Product Change Notification / SYST-19GUZD071

ERRATA - SAM D11 Series Family Silicon Errata and Data Sheet Clarifications

SAM D11 Series Family Silicon Errata and Data Sheet Clarification

FIGURE 35-2 and 40-2: POR OPERATING PRINCIPLE:

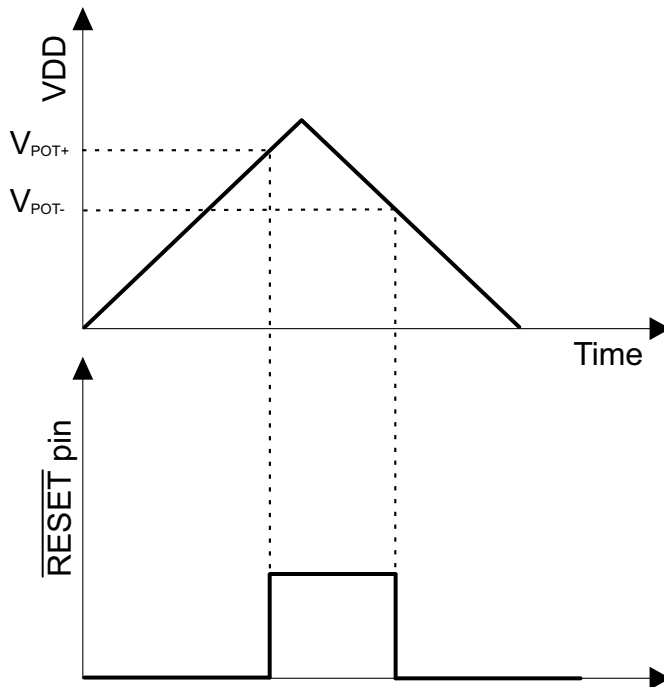
Figures 35-2, 35-3, 35-4, 40-2, 40-3, and 40-4 have an incorrect reset Polarity value. The corrected figures are as shown below:
